ATTACHMENT #1

ROUTE 605/602 INTERSECTION SAFETY IMP'S.

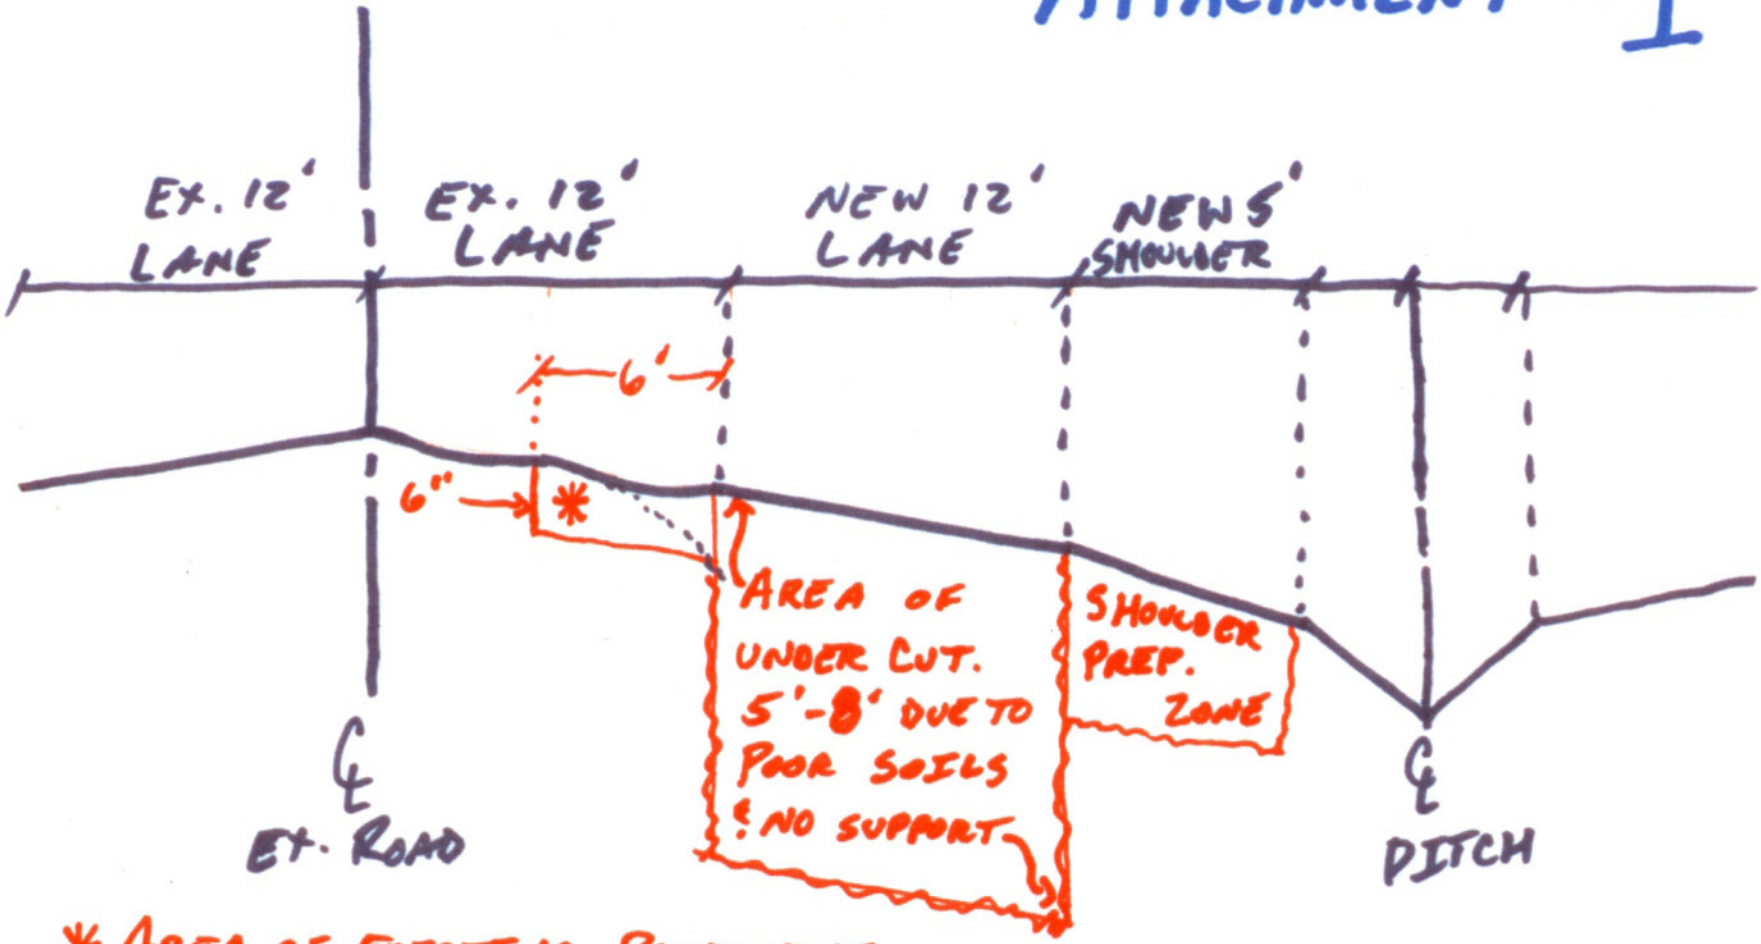
* AREA OF EXISTING PAVEMENT REQUIRING DEMOLITION, MILLING, & REPLACEMENT DUE TO EXCESSIVE UNDERCUTTING FOR NEW LANE. 6' SECTION COMPROMISED FOR LENGTH OF PROJECT.
